To: Prospective Bidders
From: Wold Architects and Engineers
Date: February 29, 2016
Comm. No: 133030

Subject: Addendum No. 2 for Bidding Documents for the: **Scott County Sheriff Patrol Headquarters**

This addendum forms a part of the Contract Documents dated February 8, 2016. Acknowledge receipt of this Addendum on the space provided on the Bid Form. Failure to do so may result in disqualification of Bid.

1 FOUNDATION PLAN
1/8" = 1'-0"

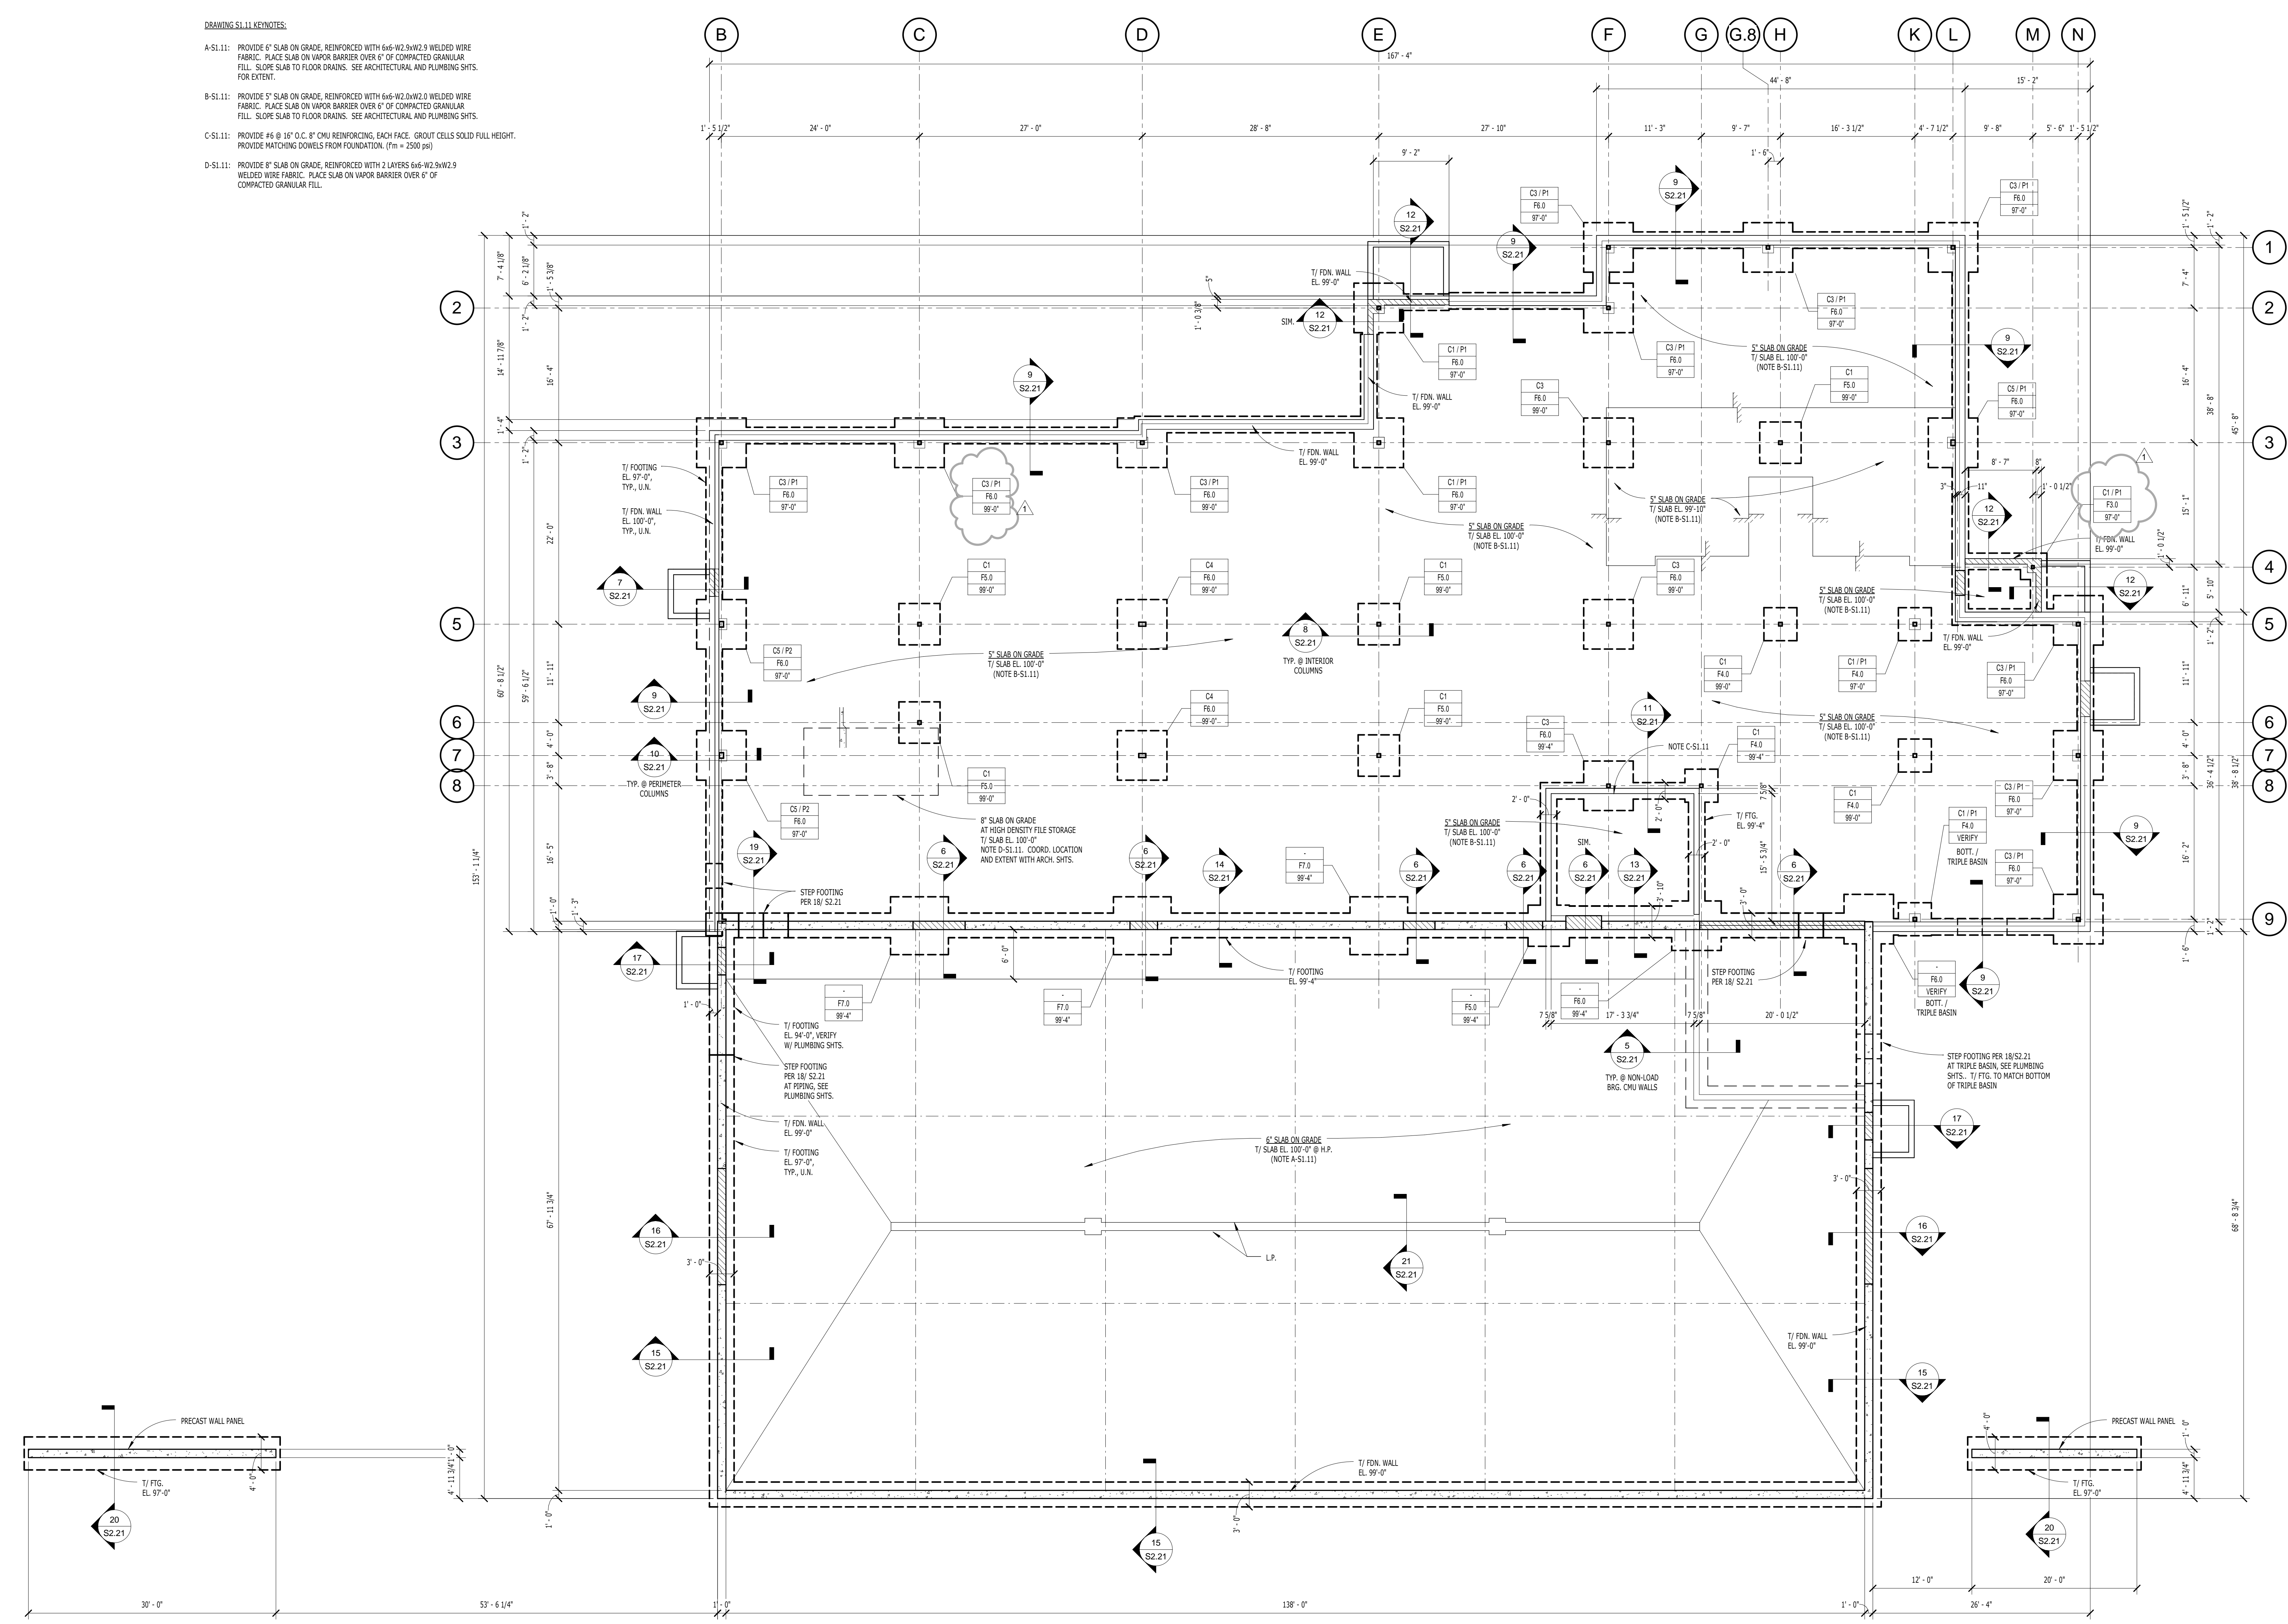
ALTERNATE No. 1- ADDITIONAL CONCRETE PAD:

PROVIDE 5" SLAB ON GRADE (24'-0" x 24'-0") REINFORCED WITH 6x6-W2.0W2.0 WELDED WIRE FABRIC. PLACE SLAB OVER 6" OF COMPACTED GRANULAR FILL. PROVIDE 8" x 4'-0" DEEP GRADE BEAM REINFORCED WITH 2 #5, TOP & BOTTOM AT PERIMETER OF SLAB. PROVIDE #4@12" O.C. (24"x24") DOWELS FROM SLAB INTO GRADE BEAM. PROVIDE 5" SLAB ON GRADE (10 FT. x 24 FT.) APRON REINFORCED WITH 6x6-W2.0W2.0 WELDED WIRE FABRIC.
